Reliability Analysis Update PJM West

Baseline Reliability Projects Changes to Previously Approved Projects

B3959.1 was presented on 11/14/2025 SR RTEP

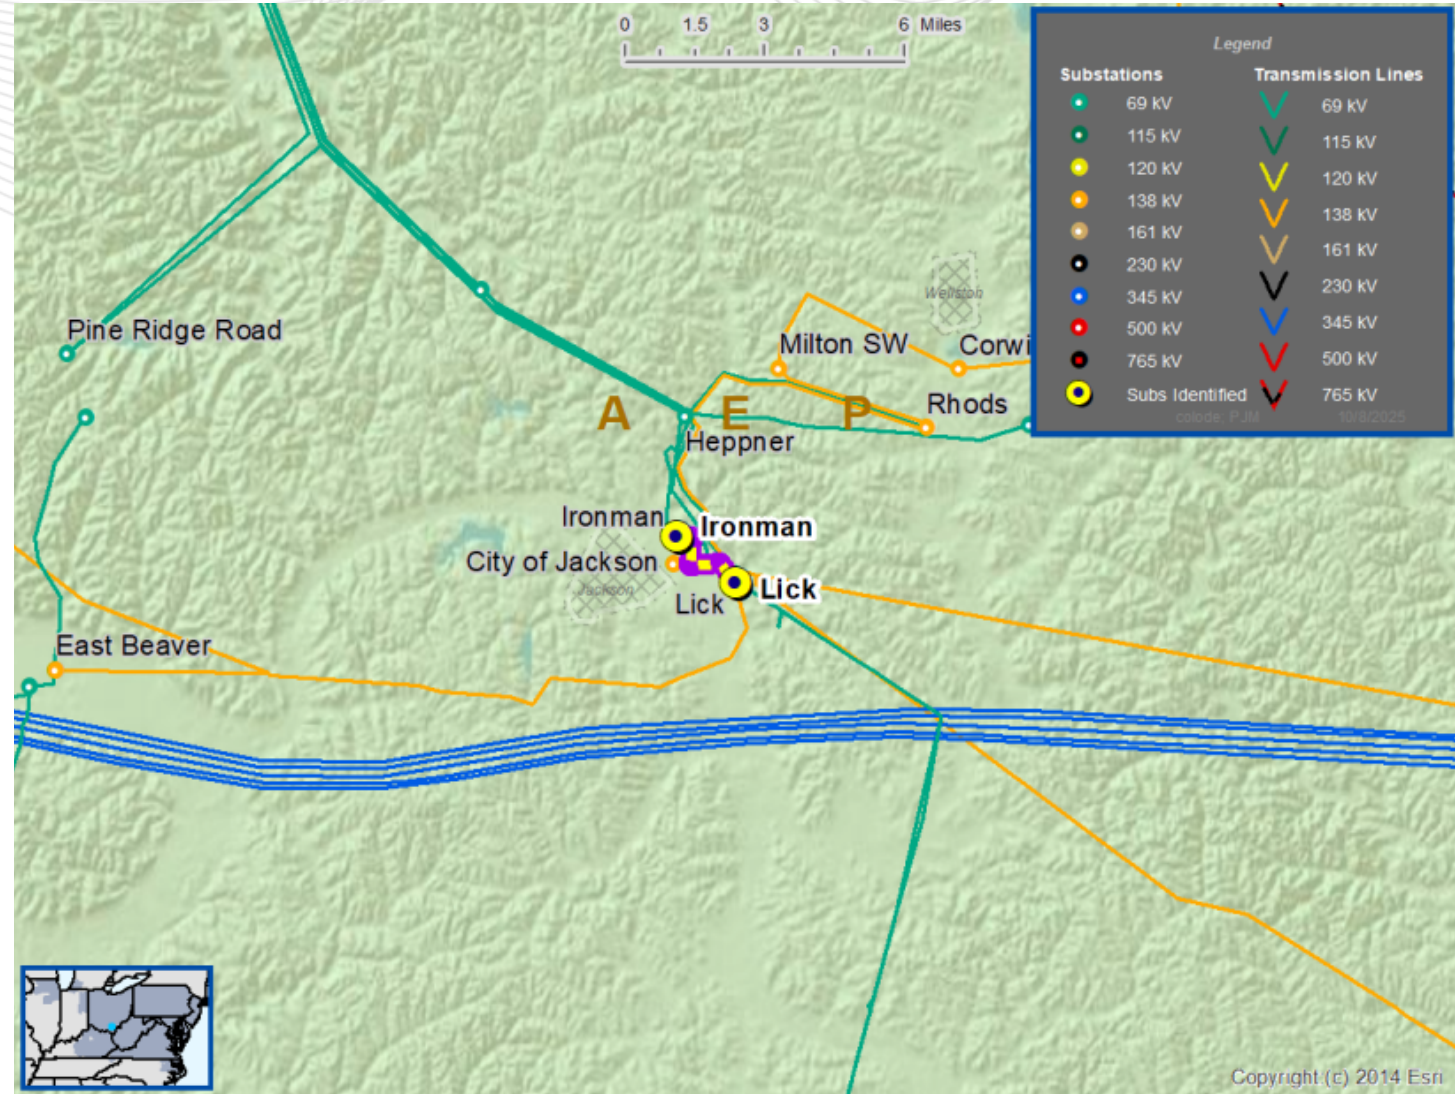
Scope: The line section overloading is roughly ~0.8 miles consisting of 336 ACSR 30/7 Oriole from structure 44 to Lick station. Reconductor limiting line conductor on the Lick-Ironman 69kV circuit to match the rest of the line. (b3959.1)

Reason for Cancellation:

Rating error in the 2025 study for Lick-Ironman 69kV circuit. With corrected ratings, the project B3959.1 is not needed.
